September 28, 2020

Product Change Notice - Above floor slide-out motor mount bracket

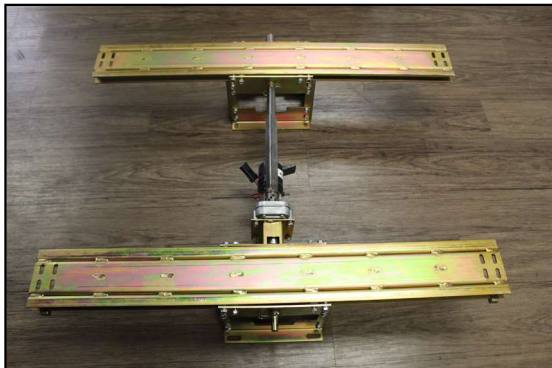
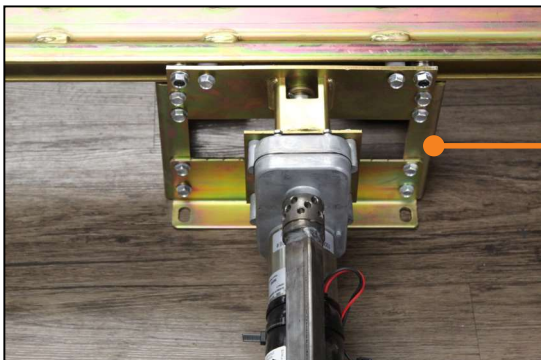
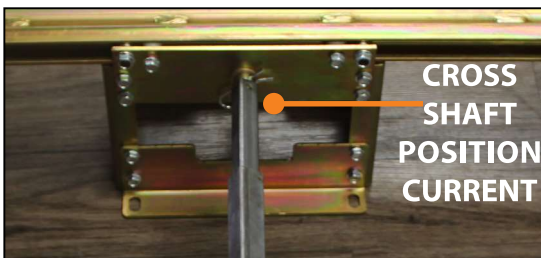
Please be advised we are changing the motor mount brackets on two above-floor slide-out systems from the original welded mount to the new bolt-on mount.

The affected slides are 367242 and 367208. The remainder of LCI's above floor slide-outs are currently using the bolt-on method. The main visible change is shifting the cross shaft 1.75" from the original location.

WELD ON
MOUNT
CURRENT

CROSS
SHAFT
POSITION
CURRENT

BOLT ON
MOUNT
NEW

CROSS
SHAFT
POSITION
NEW
